SERVICE BULLETIN

PURPOSE : CORRECTION	ISSUE NO. : MSB-07E42-503	DATE : 2007-06-20
SUBJECT : SPECIFICATIONS OF SUNROOF		<MODEL> (EUR) OUTLANDER (GS45X)(CW0W)
GROUP : BODY		<M/Y> 07

According to the correction to the specifications of the sunroof, the descriptions for the sunroof timer function have been deleted in the applicable manuals. This Service Bulletin contains the corrected descriptions.

SUNROOF MOTOR ASSEMBLY

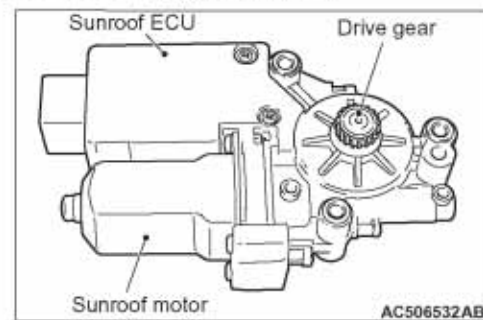
<Deleted>

SUNROOF TIMER FUNCTION

The sunroof ECU (integrated into the sunroof motor assembly) receives the ignition switch (IG1) signal transmitted by ETACS-ECU. If the ignition switch (IG1) signal turns OFF, the sunroof ECU allows the sunroof switch to open/close (timer activation) the sunroof for approximately 30 seconds. During the timer operation, if the driver's door open is detected from the door switch signal transmitted by ETACS-ECU, the sunroof ECU extends the timer for approximately 30 seconds to open/close the sunroof by the sunroof switch. However, during this timer operation, if the driver's door is closed, the sunroof timer function stops at this time.

NOTE: Using a customisation feature, the sunroof timer period can be changed (Refer to P.42A-26).
